RFP N6264926R0013 YON 285 Outfit

Additional Q&A

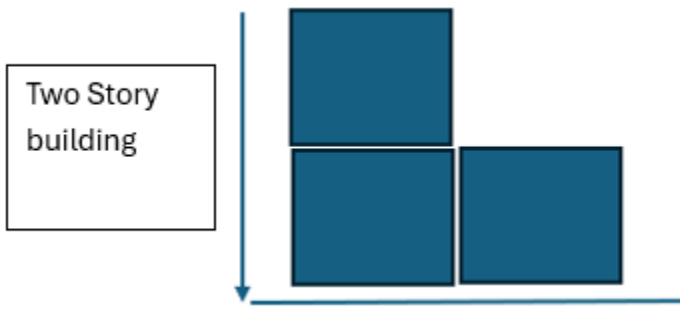
Inquiry 1: Quantity of Office Station and Unit Houses

Section 1.3.1 of the attached specification lists "One 2-story office station (2400 x 5400 x 5300H)", while sub-section 1.3.1.1 lists "Three unit houses (2400 x 5400 x 2650H)".

The wording suggests that 1.3.1.1 describes the breakdown of 1.3.1 (meaning the 2-story station should be assembled using these unit houses).

However, mathematically, three unit houses are insufficient to match the dimensions required for a 2-story structure (it would physically require six houses).

Could you clarify if the quantity "3" is a typo, or if three separate unit houses are required in addition to the 2-story office station?

A: We are requesting to have a 2 story building that has three units in a similar configuration as pictured below:
